STAFF SUMMARY REPORT (Ralph Lambert)  
MEETING DATE: February 8, 2017

**SUBJECT:** **Prosperity Cleaners, Marinwood Plaza, 187 Marinwood Avenue, San Rafael, Marin County** – Status Report on Cleanup Plans and Activities

**SUBJECT:** **Former Prosperity Cleaners, 187 Marinwood Avenue, Marinwood, Marin County - Water Board Responses to Comments on the Revised Rap Addendum #3, Groundwater Remedial Action Feasibility Study**

**Subject: Review of Proposed Remedial Action Plan for Former Prosperity Cleaners**

**Figure 13**  
**Map Showing  
Injection Boring Grid for  
Alternative 3**

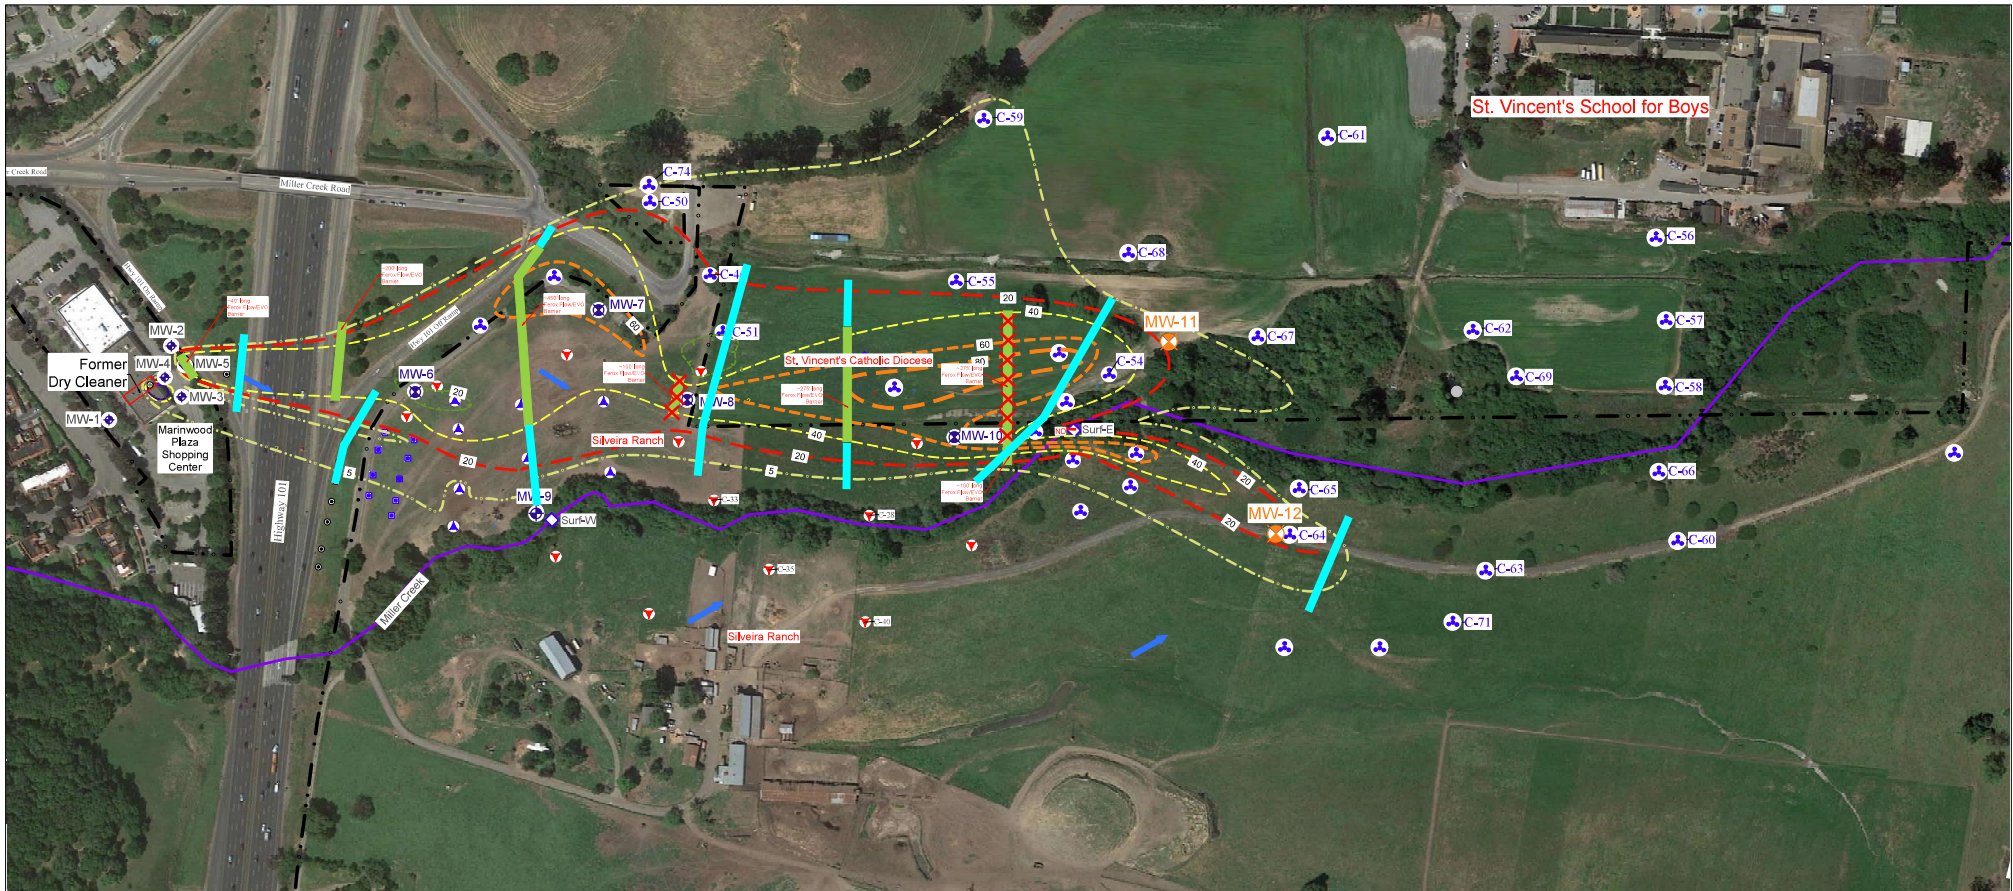
2. **Comment:** *The proposed treatment lines proposed, while an improvement over the prior proposal, would only treat to about the 40 µg/L total VOC contour line. The treatment lines should be extended to fully encompass the 5 µg/l total VOC contour line.*

3. **Comment:** *The treatment lines should be closer together than proposed to shorten the cleanup time and/or more closely match the stated spacing of 350 feet apart.*

4. **Comment:** *There is a discrepancy between the text where it says treatment lines are approximately 350 feet apart and the proposed location map (Figure 13).*

The previously recommended array of treatment grid lines that I proposed on September 20, 2016 (see attached map) is far more likely to accomplish the required remediation within the 10-year timeframe required by the Water Board. The treatment grid lines now being proposed by Geologica (see Figure 13) would only treat to about the 40 ug/L VOC contour line in the groundwater plume, leaving the remainder of the contaminated plume roughly 35 ug/L above the target clean up goals. SGI realizes that the contours are an interpretation of the plume location, but they are located based on

It appears there is a slight discrepancy between the Geologica text and the map of the treatment line spacing. The text states that treatment lines are approximately 350 feet apart, the map shows lines are over 400 feet apart. This discrepancy is not enough to change the proposed locations spacing. The addition of two treatment lines as proposed by SGI (9/20/16) would shorten some of the treatment time near the source area and benefit the treatment of the downgradient plume by reducing the mass of VOCs requiring destruction to the west.

**Response:** The length of the treatment lines will be determined by the results of the pilot test and it will not be necessary to extend the treatment lines to the 5 µg/l total VOC contour line in order to meet chemical-specific cleanup levels within 10 years. A review of the sample data shows the recommended extended treatment lines may intercept groundwater from an additional 20 sample locations. Of this additional sample data the two highest concentrations were between 20 and 30 µg/L PCE. Fourteen of the locations (70%) showed PCE at 10 µg/L or less. This data indicates that most of the expanded treatment lines would treat very low concentrations. The final locations and extent of injections may well differ from those currently proposed.

**Response:** Treatment line spacing is based on an assumption of groundwater flow rate. Groundwater flow rate will be determined as part of the pilot testing and associated investigation. This data will then be used to determine the final spacing of the treatment lines needed to accomplish full cleanup within 10 years.

**Response:** We agree that the spacing on Figure 13 is not consistent and does not match the text. The final locations will be based on the results of additional investigation and the pilot tests so that groundwater cleanup levels are met within 10 years. Also, see the response to comment #3 above.
